PART B – AEIS

14. SURFACE WATER

14.1. Water resource modelling (IQQM)

Figure 14-43

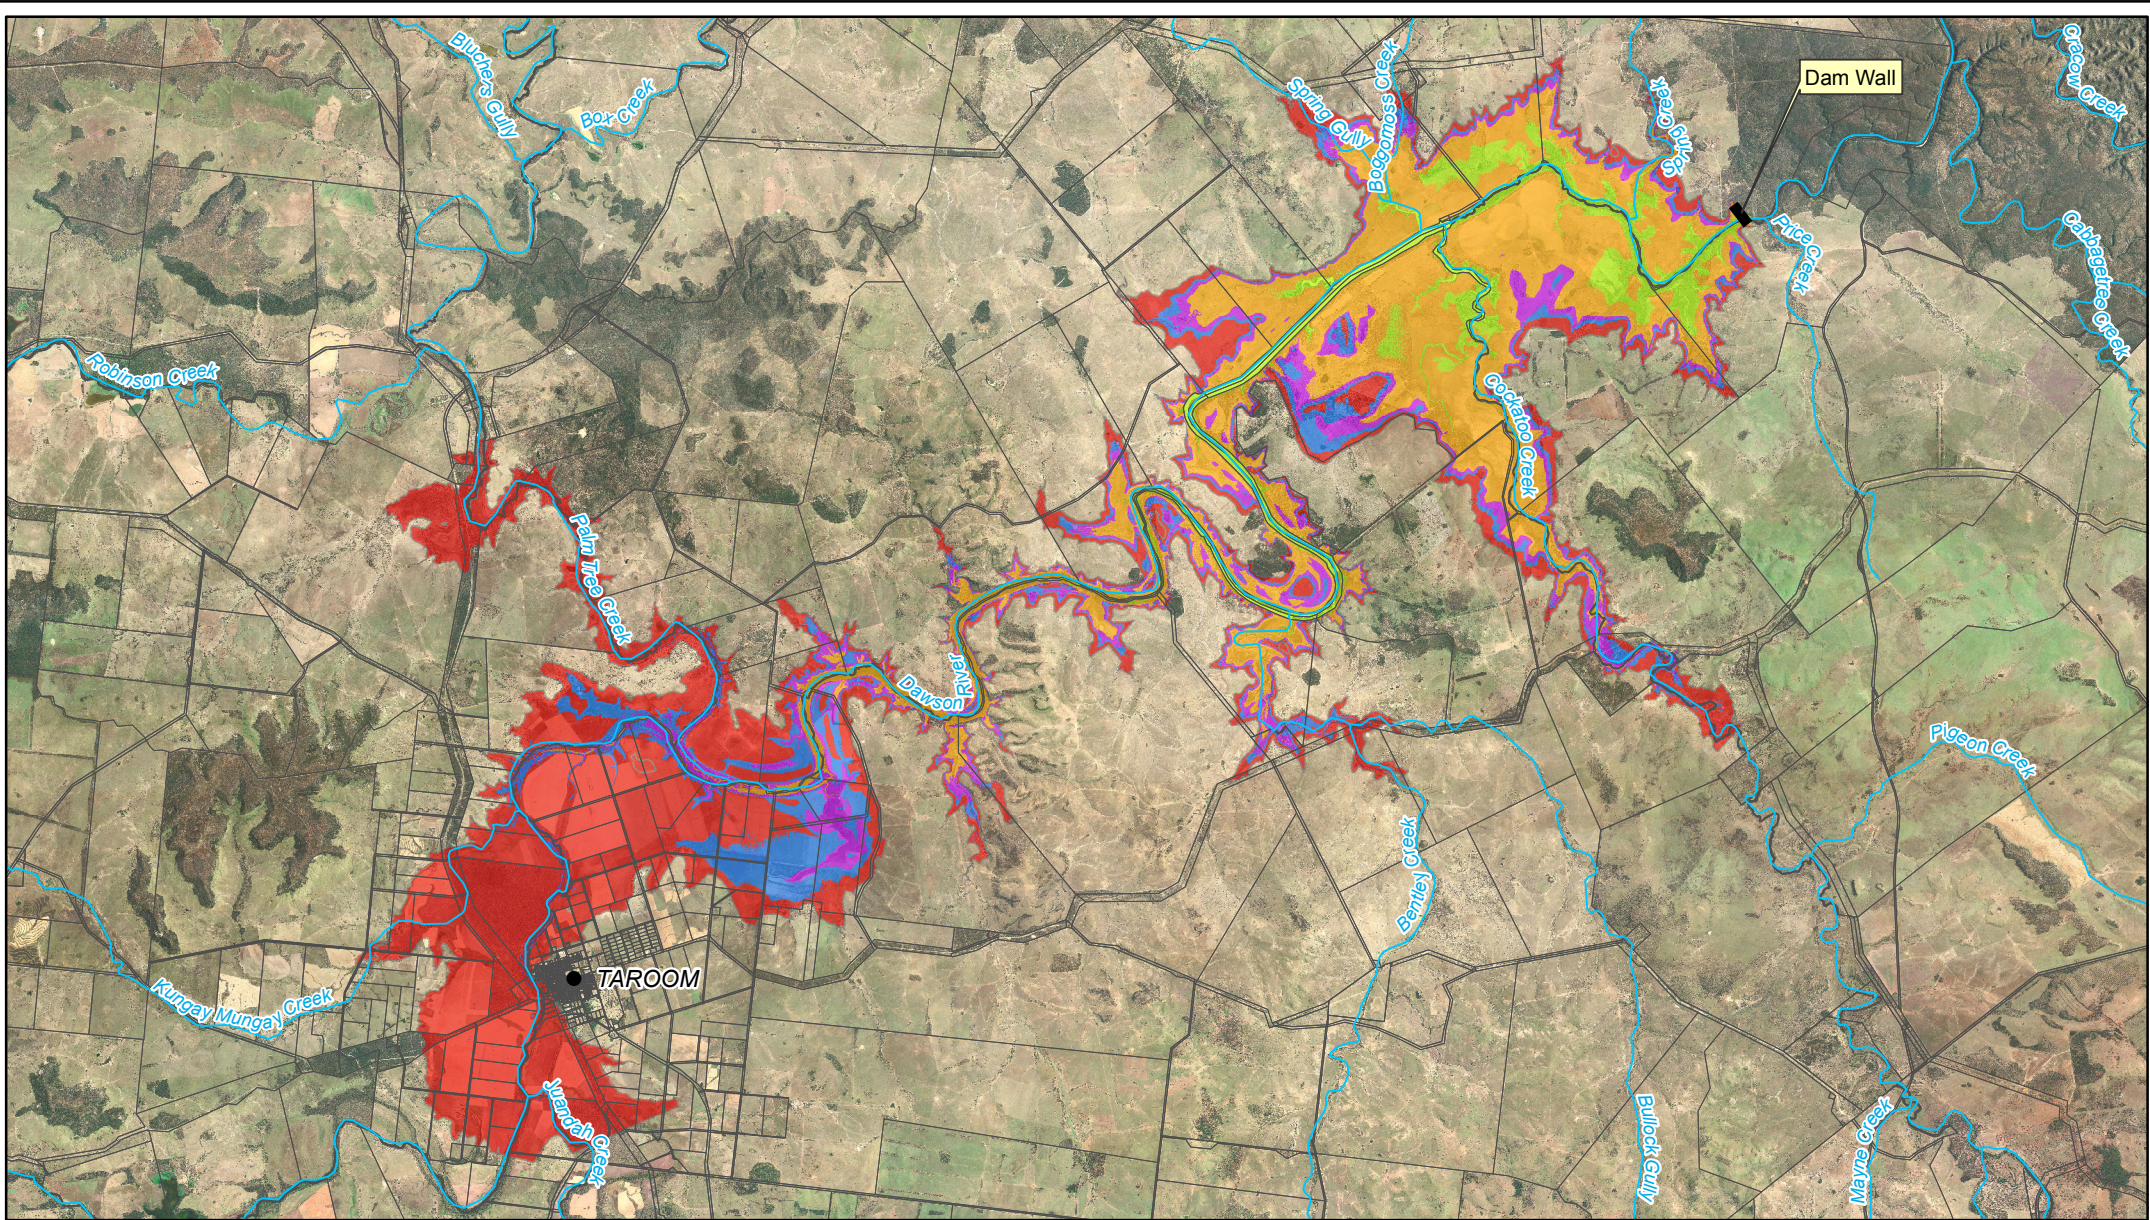
Several submissions were concerned about flood levels in Taroom and whether plans had been developed to protect Taroom from additional flood risks.

There are two buildings in Taroom that are predicted to be located between the FSL extent and the 1 in 100 AEP flood extent with the dam in place. The floor levels of these buildings are unknown. The potential impact on properties will be further investigated during the detailed design of the dam. If habitable floor levels are found to be below the 1 in 100 AEP flood level mitigation strategies will be developed in consultation with the property owners. An example of the strategies that may be considered include, building modifications to increase flood resilience, house raising, relocation of the house on the block or voluntary purchase of the property.

For flood events more frequent than the 1 in 100 AEP the difference in flood peaks, pre and post dam, is less than 0.6 m. For example, there will be no change to peak flood levels for events up to the 1 in 10 AEP (equivalent to the BoM minor to major flood classification at Taroom); while the difference in flood peaks for the 1 in 20 AEP and the 1 in 50 AEP is +0.1 m and +0.3 m, respectively.

A levee to protect Taroom from flooding is not proposed. Plans to manage the higher flood levels involve SunWater negotiating easements with property owners of land and residences, so that further development or construction will not expose the residents to flood risk. A flood management plan will also be developed for Nathan Dam. This will primarily focus on managing dam safety risks under extreme events; however, scope exists to consider how the dam outlets could be used to release additional water, in order to manage upstream flooding.
